# UNITED STATES PATENT AND TRADEMARK OFFICE

APPLICATION NO.	FILING DATE	FIRST NAMED INVENTOR	ATTORNEY DOCKET NO.	CONFIRMATION NO.
10/049,597	02/14/2002	Francis Mouyen	49316/280551	9713

**Office Action Summary**

**DETAILED ACTION*****Claim Rejections - 35 USC § 103***

Figure 1 - U.S. Patent 4,995,062 to Schulza-Ganzlin et al.

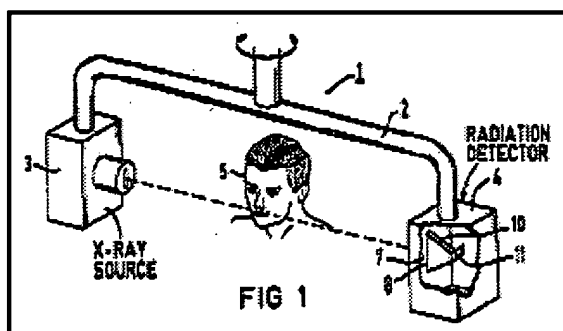
5. As per claim 1, Schulza-Ganzlin et al. disclose a method comprising the steps of emitting a bundle of X-rays in the direction of a tooth and its surrounding area and guiding the X-rays that emerge from the tooth and its surrounding area; transforming X-rays into light rays of a greater wavelength than that of X-rays (Fig. 2, #9; column 3, lines 5-6); converting these light rays into electrical signals and processing these signals to produce radiographic data (abstract). Schulza-Ganzlin et al. do not explicitly disclose the step of guiding emerging X-rays into substantially cylindrical rods substantially along the axis of the volume.

14. As per claim 5, Schulza-Ganzlin et al. as modified above disclose an apparatus comprising a source (Schulza-Ganzlin et al.- 3); a plurality of cylindrical rods (Mouyen - 40) capable of transforming x-rays into light rays of wavelengths greater than x-rays; means (Schulza-Ganzlin et al.- 11) for converting light rays into electrical signals; means (Schulza-Ganzlin et al.- 10) for connecting cylindrical rods to means (11) and means for processing electrical signals (Schulza-Ganzlin et al.-16, 17, 18, 29, 20, 21).

31. Applicant contends that the cited references teach away from each other. Applicant cites the disclosure of Schulza-Ganzlin et al. as relating to the use of a transmission or coupling element ((10)- see Fig. 1 above), such as fiber optics (column 3, lines 1-11). Applicant supports the position that the disclosures are divergent by also citing in Mouyen ('798) that the method

32. Examiner notes however, that Schulza-Ganzlin et al. in describing the invention give an illustrative example of a transmitting or coupling element, of which fiber optics can be used. Examiner treats the disclosure of element (10) as not being limited only to fiber optics, but encompasses any elements that could satisfactorily provide/ possess a transmitting or coupling function (see also Schulza-Ganzlin et al. column 7, lines 54-59). Examiner further notes that the cylindrical rods of Mouyen possess transmitting/coupling capabilities. Therefore, examiner concludes that the coupling element of Mouyen may reasonably be applied to the method and apparatus of Schulza-Ganzlin et al. and the aforementioned references do not teach away from each other as they are in agreement with regards to transmitting/coupling elements.

Figure 4 - U.S. Patent 4,995,062 to Schulza-Ganzlin et al.

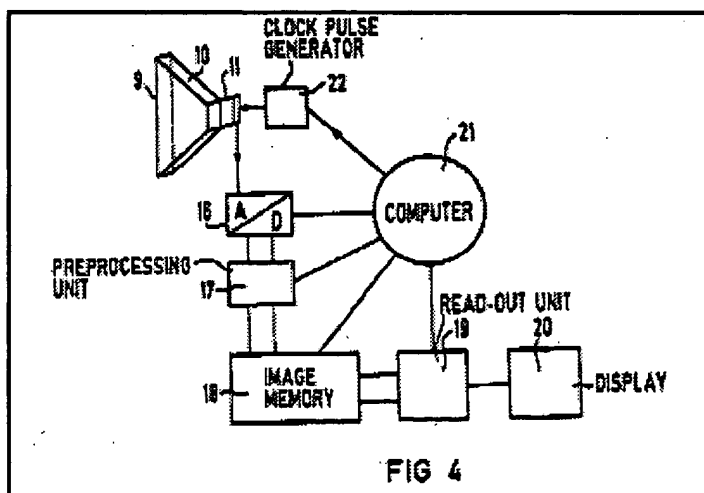
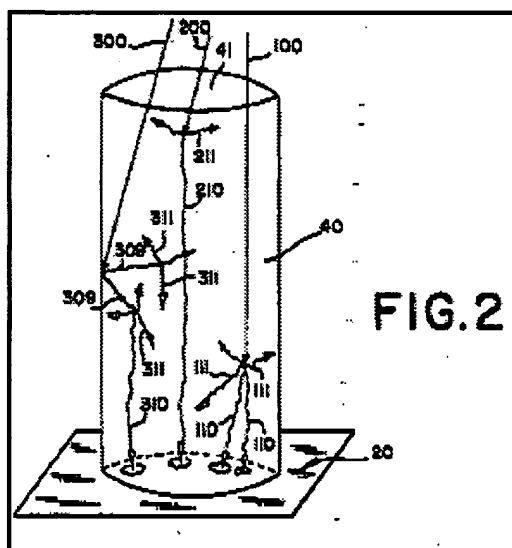
11. As per claim 3, Schulza-Ganzlin et al. as modified above, disclose a method comprising converting light rays into analogue signals and subsequently into digital electrical signals (Schulza-Ganzlin et al.; Fig. 4-16)

15. As per claim 6, Schulza-Ganzlin et al. as modified above disclose an apparatus configured to convert light rays into analogue signals and a converter for converting analogue signals into digital signals (see Schulza-Ganzlin et al.; Fig. 4-16).

16. As per claim 7, Schulza-Ganzlin et al. as modified above disclose an apparatus comprising a CCD bar (see Schulza-Ganzlin et al.; Fig. 4-11) for converting light rays into analogue signals. Schulza-Ganzlin et al. do not explicitly disclose an apparatus comprising a CAN converter for converting analogue signals into digital signals.

17. Schulza-Ganzlin et al. teach the use of a converter (16) for converting analogue signals to digital signals.

Figures 1 and 2 - U.S. Patent 5,382,798 to Mouyen

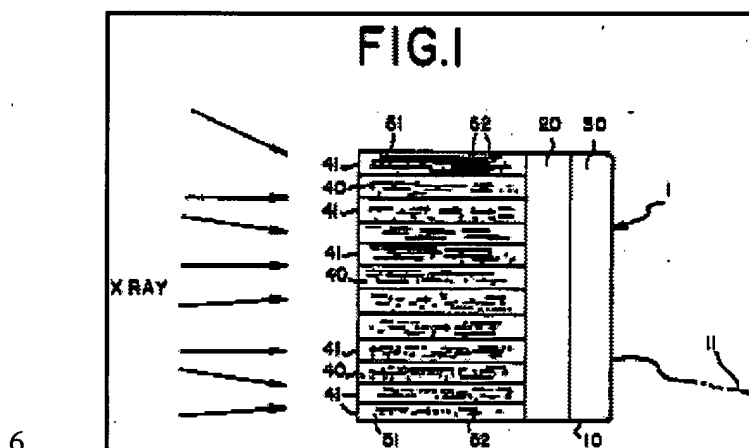
7. Mouyen discloses a method comprising the step of guiding emerging X-rays (200) into substantially cylindrical rods (40) substantially along the axis of the volume. Mouyen teaches that guiding emerging X-rays results in the formation of high quality pictures (column 1, lines 36-41).

8. It would have been obvious to modify the method of Schulza-Ganzlin et al. such that it incorporated the step of guiding emerging X-rays into substantially cylindrical rods substantially along the axis of the volume. One would have been motivated to make such a modification so that received radiation is used to form high quality pictures, by reducing diffuse radiation as taught by Mouyen (column 1, lines 36-41; column 3, lines 51-63).

36. Figures 2 - U.S. Patent 5,382,798 to Mouyen

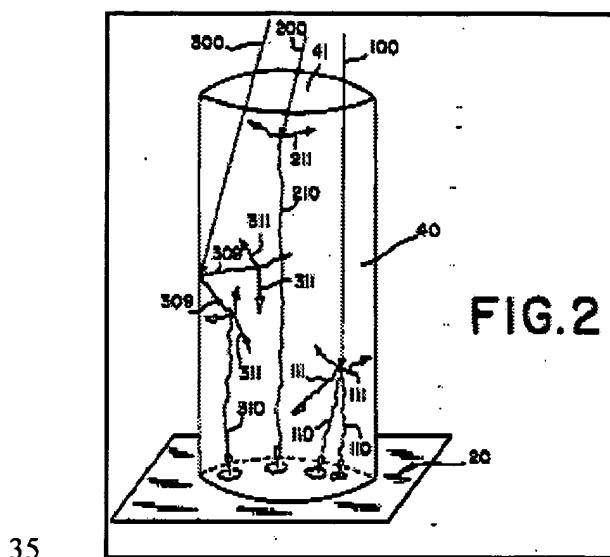
37. Mouyen ('798) – Fig. 2, teaches the interaction of radiation beams (100, 200 and 300) as they pass through an object of interest and traverse through cylindrical rod (40) and enter the face of a receiving sensor (20). It is noted that the Mouyen ('798) teaches that diffuse or secondary rays (200) or lateral primary rays (300) that enter cylindrical rod (40) do not (and will not) contribute significantly to the formation of an image as their energies are absorbed while traveling through the rod. However, Mouyen teaches that only primary rays (100) that enter rod (40) substantially along the rod's length-wise axis will contribute significantly to image generation (see Mouyen ('798) – column 3, lines 1-39).

38. Examiner contends that Applicant's conclusion is based only with regards to rays 200 and 300, and has failed to address the treatment of primary ray 100. Examiner further contends that in radiation imaging it is often the non-oblique beams that contribute to sharp image generation (i.e. less cross talk among detection elements, resulting in sharper image contrasts and higher image definitions).
